# Technical Service Bulletin

**NUMBER:** 23-30-00

Front seat belts may be slow to retract.

1999 - 2000 (WJ) Grand Cherokee

**FIGURE 1**

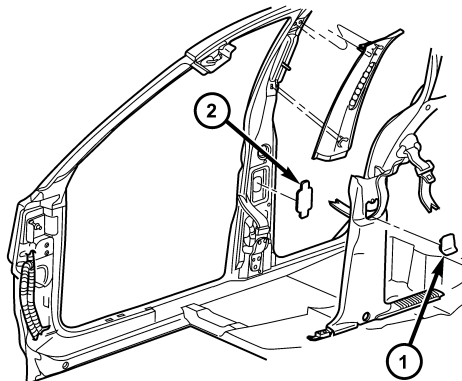
The seat belt webbing may come in contact with the wire harness causing the belt to retract slowly.

Remove the seat belt access cover from the B Pillar trim panel and inspect the seat belt for contact with the wire harness (See Figure 1). If contact is evident, perform the Repair Procedure.

1. Remove the B Pillar trim panel (See Figure 1).

2. Install the shield, p/n 55116545AB, into the opening by inserting the tabs one at a time.
3. Install the trim panel
